**GOVERNMENT OF TELANGANA
FOREST DEPARTMENT**

Ref.No.10947/2020/FCA.1, Dated.10.01.2022.

Sub:- TSFD – F(C) Act, 1980 – Diversion of forest land for **4.32ha** of Forest Land for improvement of existing road and widening road from **Narsapur-G to Gollamada** via Anjani Thanda, Thimmapur of Narsapur-G Mandal in **Kusli RF and Pyaramoor and Narsapur RFs of Nirmal forest division** in favour of Panchayathi Raj Engineer, Nirmal-Additional information furnished - Regarding.

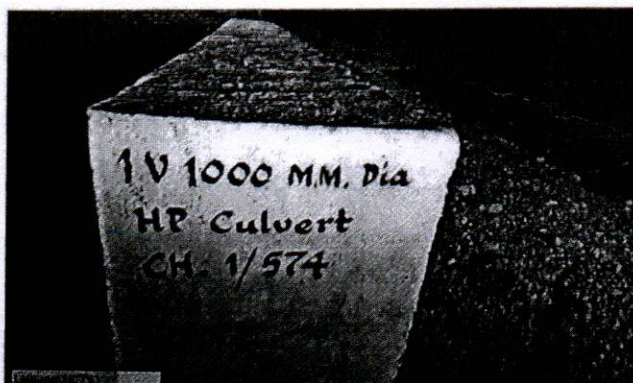
During inspection, it was noticed that User Agency has violated FCA,1980 norms and started road construction. Work in violation has been carried out by the User Agency which are following :

1. The User Agency has attempted and nearly completed the road work over an length of 5.760 Km in the proposed area and complete road has been black topped. Hence the forest area involved in violation comes to 5.760 Km X 7.50 Mtr width = 4.32 Ha. Even the condition of laying speed breakers at every 500metre length to control speed and signage on both sides regarding wildlife protection has not been followed.
2. Some culverts which are just outside the RF and bordering RF are yet to be plastered and cemented. Photos of some of the completed culvert is attached as above.

Show cause noticed has been issued to the user agency vide this office Rc. No. 2440/2020/S1, Dated 05.07.2021.
